## SUBMISSION - STATE ASSESSED PLANNING PROPOSAL - COWPER STREET, WARRAWONG

DRAWING TITLE  
**LEP AMENDMENTS -  
HEIGHT**

### **SUBMISSION: STATE ASSESSED PLANNING PROPOSAL – COWPER STREET, WARRAWONG**

Figure 4 - Proposed Ground Floor Plan, reference design (CHROFI)

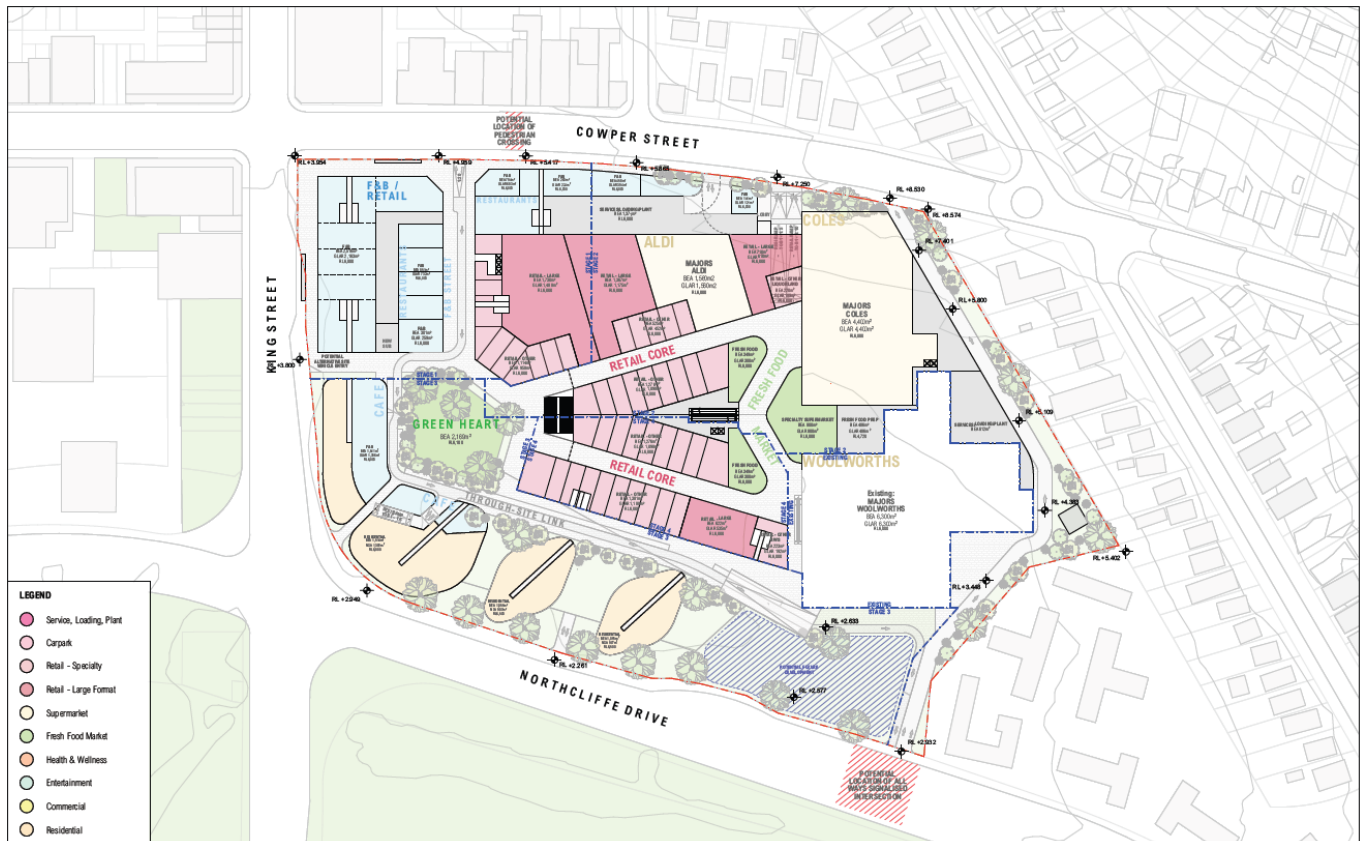
The location and orientation of the 'Green Heart' is questioned. As currently proposed, the space is internalised within the site and there are CPTED concerns around visibility, passive surveillance, and street activation. The ownership and management arrangements for the proposed open space will need to be determined.

The location, size, and nature of pedestrian access points into the site does not promote a pedestrian focused environment. The WCC Warrawong Town Centre Masterplan aims to provide permeable and safe pedestrian connections to Cowper Street increasing its convenience and attraction as the main street. The proposal does not align with this objective as it has multiple vehicular entry and/or exit points along the Cowper Street frontage. This is not supported.

The proposed through site link is not supported in its current form. It is convoluted and vehicular dominated and does not provide safe permeability through the site. The volume of traffic that is likely to utilise this link will not create a safe or pleasant movement corridor for people walking. It appears that pedestrian desire lines and view lines have not been considered when establishing the through site link. If a community outdoor space is located along Cowper Street (as indicated in the masterplan) this could then provide an entry point for a pedestrian focused through site link that runs directly north-south through the site separating the “Gateway Building” from the residential towers to the south-east. It would then allow the possibility of providing a good portion of the retail core along the west portion of the site.

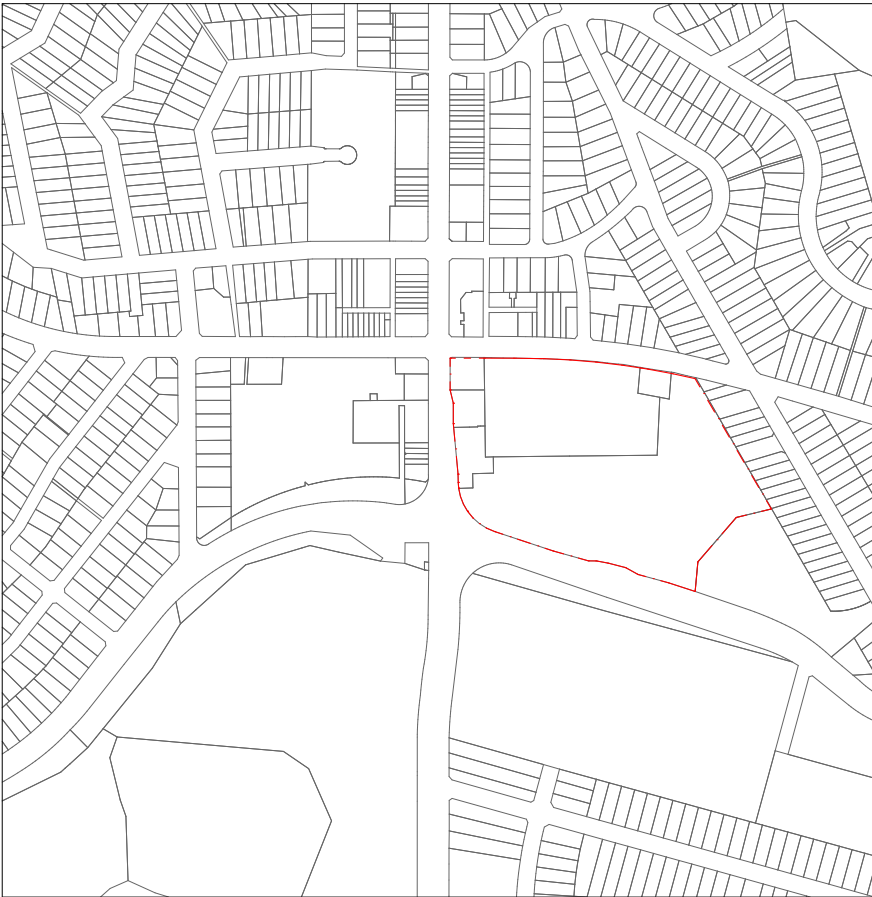
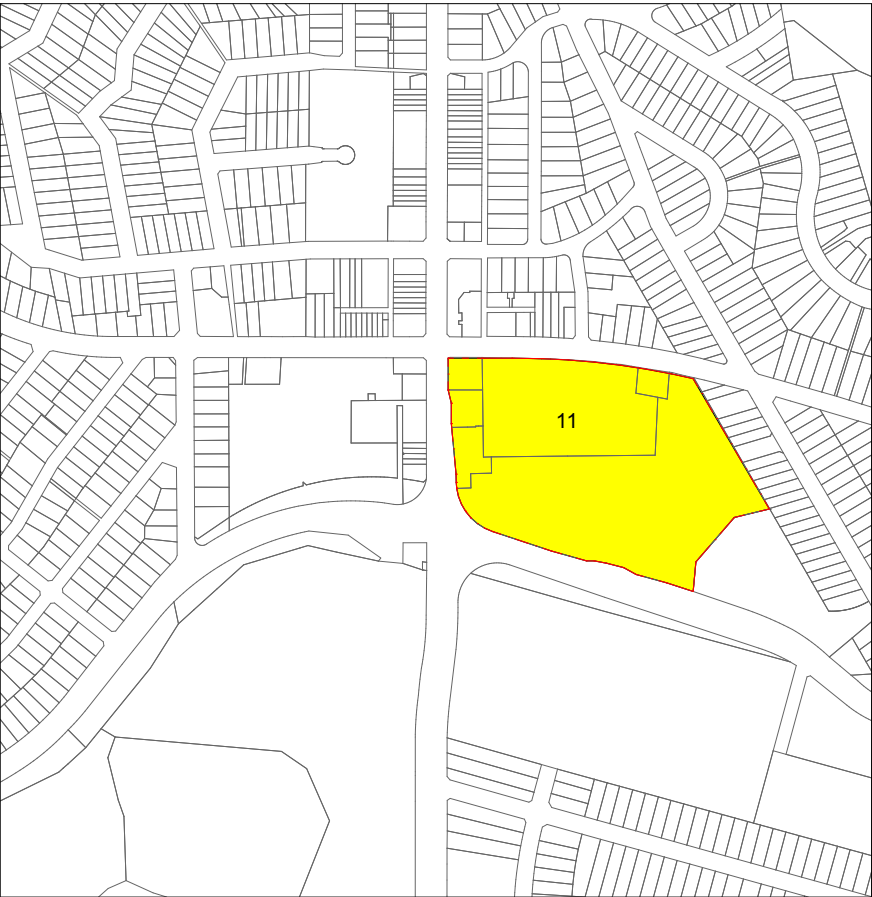
The Planning Proposal seeks to amend the LEP HOB from 24m to a range of heights including 24m, 36m, 41m, 45m, 50m, 51m, 66m, 77m and 78m. The Planning Proposal does not suggest or incorporate any changes to heights in the remainder of the Centre. It is understood that these increases are intended to be contained to the subject site only.

The overshadowing diagrams provided within the reference design documents show that shadows fall onto these open spaces to varying levels. The EIE (p.26) suggests that the distribution of height across the site would allow “overshadowing impacts to be concentrated over open space as opposed to more sensitive uses”. This argument is not supported. The amenity and functionality of open space should be maintained, particularly as population growth often leads to increase demand for formal and informal use of public spaces. Should the proposal proceed, it is recommended that solar access protections for the public recreation/open space areas are included within the LEP to protect public open spaces from unreasonable overshadowing irrespective of the final design of any redevelopment. The clause should be supported by maps and referenced within Clause 4.6(8) to protect against cumulative impacts of encroachments over time. This approach is consistent with the *Guide to exclusions from clause 4.6 of the Standard Instrument* (DPE 2023).

DRAWING TITLE	DRAWING NUMBER	REVISION
LEP AMENDMENTS - ACTIVE STREET FRONTAGES	A-PP-005	G

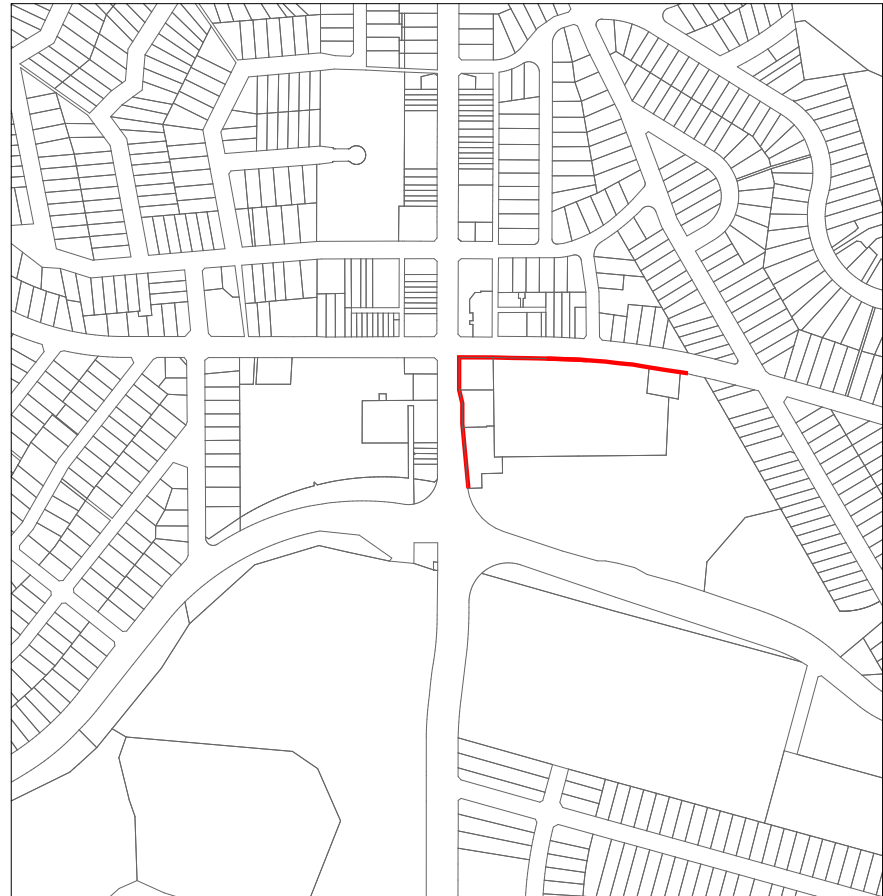
The planning proposal includes a mapped active frontage under clause 7.19, meaning clause 7.13 would not apply to the remainder of any identified lot. The proposal also seeks an Additional Permitted Use to enable residential flat buildings to be permitted with consent. Residential flat buildings are currently prohibited within the E2 Commercial Centre zone. The combination of mapped active frontages and the proposed APU, ultimately “unlocks” the ability for residential uses at ground level in certain locations, such as along Northcliffe Drive.

It is important to note that the Wollongong DCP 2009 also includes active frontage controls (DCP Chapter B4 10.4.2), which do not impact land use permissibility in the same way that LEP clause 7.13 does. Rather these controls outline in detail how the frontage is to perform, including some prescriptive controls regarding the composition and materiality of shopfronts. These controls apply to ‘all new retail, business or mixed-use buildings’. It is noted that an active frontage (with covered awnings) is not mapped along Northcliffe Drive except for the corner with King Street (clause 6.2). Within the context of the DCP this releases development from the performance and prescriptive active frontage controls in this location, but has no impact on the applicability of Clause 7.13 in the LEP.
